APPEAL SUMMARY

Appeal ID: 20424	Project Address: 7 SE Stark St
Hearing Date: 5/22/19	Appellant Name: Jared Diganci
Case No.: B-009	Appellant Phone: (503) 234-2945
Appeal Type: Building	Plans Examiner/Inspector: Brian McCall, Corey Stanley
Project Type: commercial	Stories: 10 Occupancy: B, M, S-2, S-1, A-3 Construction Type: I-B
Building/Business Name:	Fire Sprinklers: Yes - Entire Building
Appeal Involves: Erection of a new structure	LUR or Permit Application No.: 17-160571-CO
Plan Submitted Option: pdf [File 1] [File 2] [File 3]	Proposed use: Mixed Use Development

Code Section 704.2

Issue: 7 SE Stark - 704.2 Appeal EXHIBIT 2

EXHIBIT 1: Plan Diagram
LEVEL 6

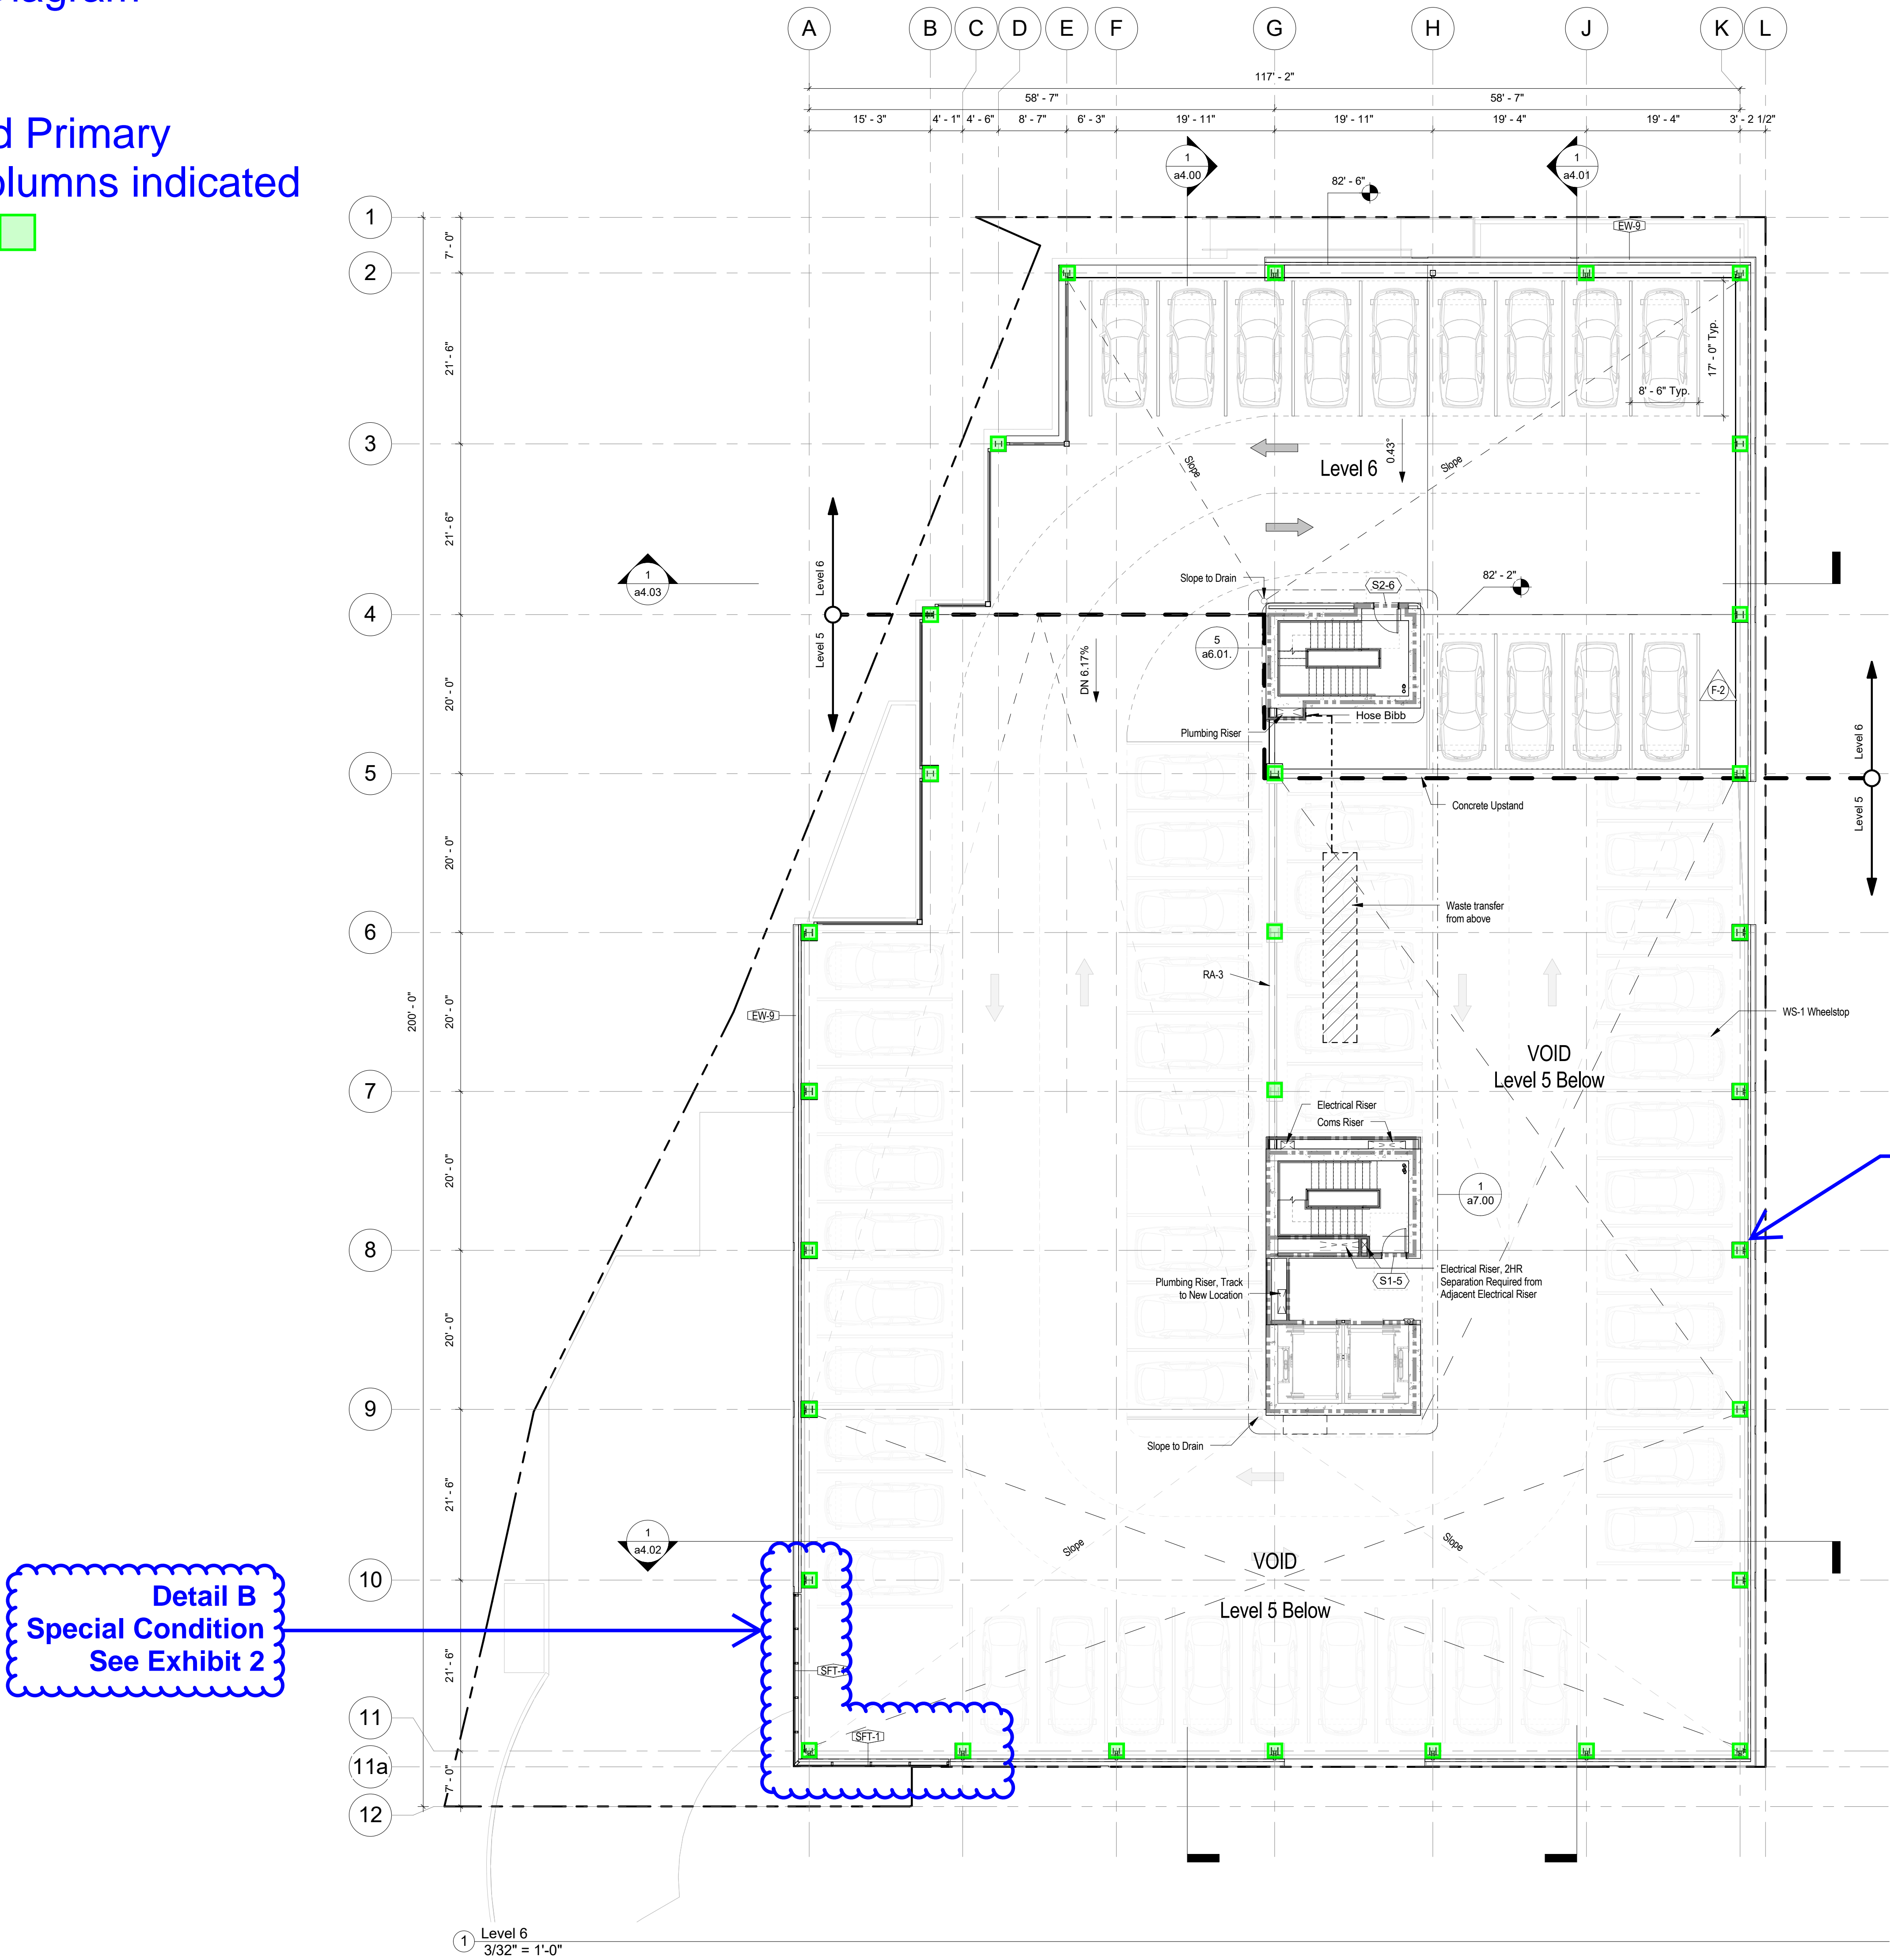
The top level of the parking garage has 1-HR FRR steel columns which support the composite steel deck above. Steel outriggers for cladding/guardrail cable attachment are connected to the 1-HR FRR columns. We propose wrapping the primary structure steel columns in (2) layers of ½" gypsum wallboard (Type X) to exceed the 1-HR minimum rated requirement (Refer to Exhibit 3 and Figure 722.5.1(4) "Fire Resistance of Structural Steel Columns Protected with Various Thicknesses of Type X Gypsum Wallboard"). Penetrations through the gypsum board by the outriggers and guardrail cable will be sealed with fire caulking. Spray-Fireproofing at the ceiling will overlap the rated gypsum column wrap to provide continuity of fire-resistance rating.

Reason for alternative Providing 1-HR FRR protection for the primary steel column was proving to have constructability problems regarding adhesion issues with spray fireproofing where the outriggers connected to the columns. Therefore, we are proposing to wrap the columns with (2) layers of ½" gypsum wallboard (Type X) and seal penetrations with fire caulking per manufacturers requirements to provide equivalency and more than the required minimum 1-HR FRR of the steel columns (Refer to Exhibit 3)

Locations of Rated Primary
Structure Steel Columns indicated
with **GREEN** Box

**Alternate 1 hour fire rated column assembly with engineering analysis: Denied. Proposal does not provide equivalent Life Safety protection.
 Appellant may contact John Butler (503 823-7339) with questions.**

SK-39.0

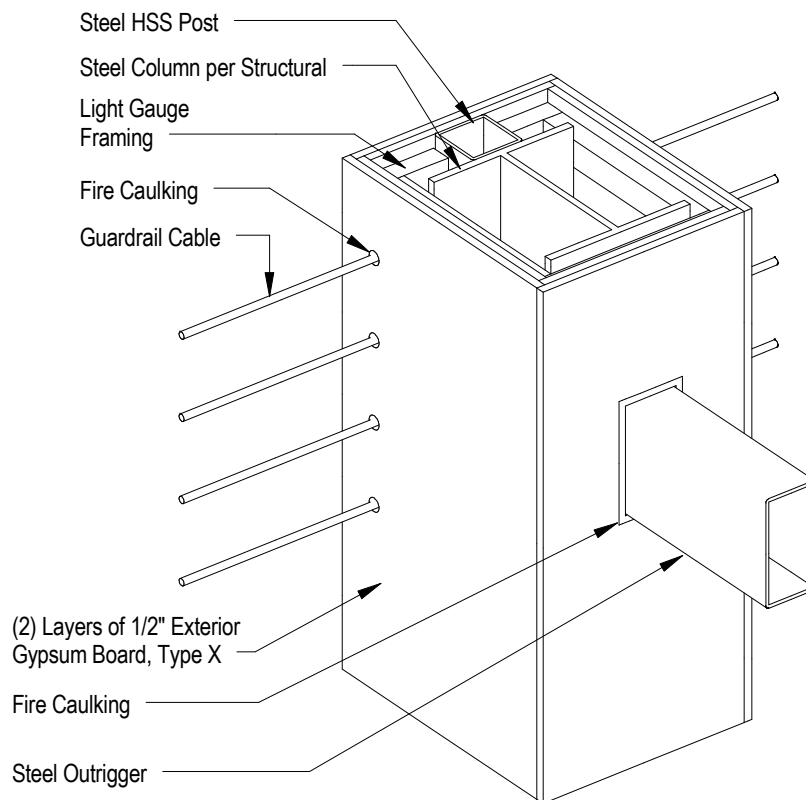
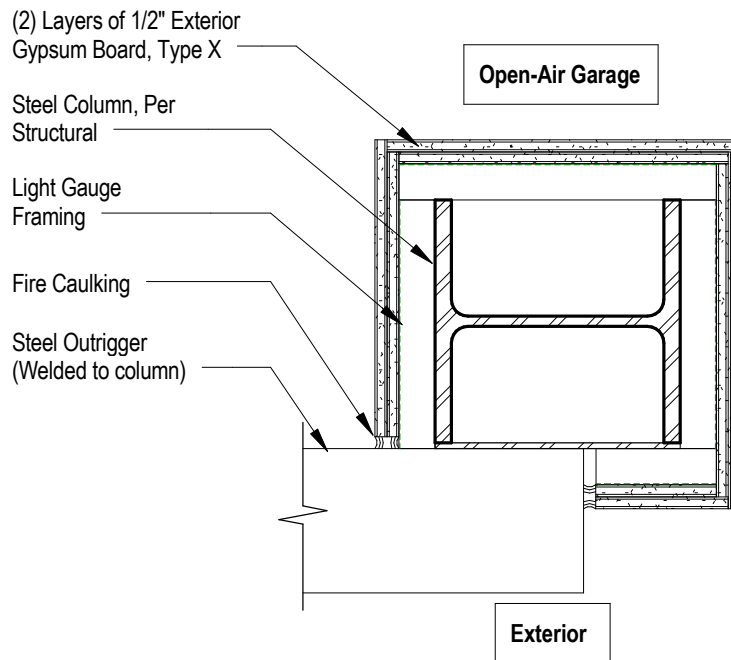
Approximately 30 primary structure, wide-flange, steel columns will be wrapped with two layers of ½-inch Type X gypsum wallboard. This 1-inch thickness Type X gypsum wallboard provides more than 1-hour of fire resistance for the steel columns. See drawings SK-39.0 and SK-39.1

Outrigger to column attachment

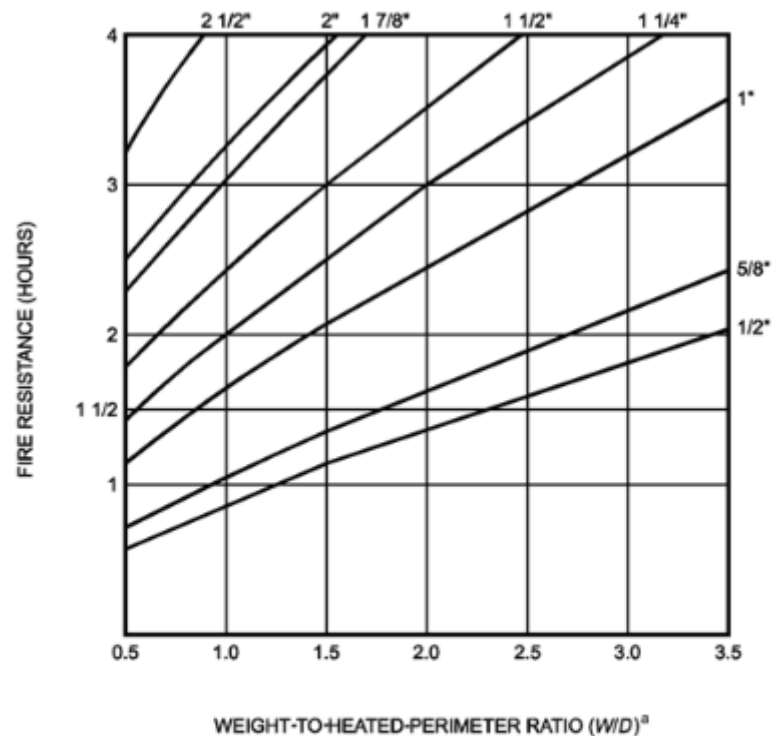
- Penetration of guardrail cable of the column protection. This is a reoccurring condition where guardrail cable is attached to the columns.
- Penetration of steel outriggers of the column protection. This condition occurs a maximum of one per column and only on selected columns.

Both the cable guardrail and HSS outrigger penetrations of the gypsum wallboard fire wrap provide conduction paths for heating of the steel columns. This is a negative attribute of the design. However the overdesign of the fire wrap slows heat transfer to the columns. This is a positive attribute. From a surface area standpoint the overdesigned fire wrap is more than an order of magnitude greater than the area of the non-compliant penetrations. The area of the penetrations of the column encasement is substantially smaller than the area of the gypsum wallboard encasement which provides greater fire resistance than required by OSSC (2014). The better than code column encasement compensates for the penetrations.
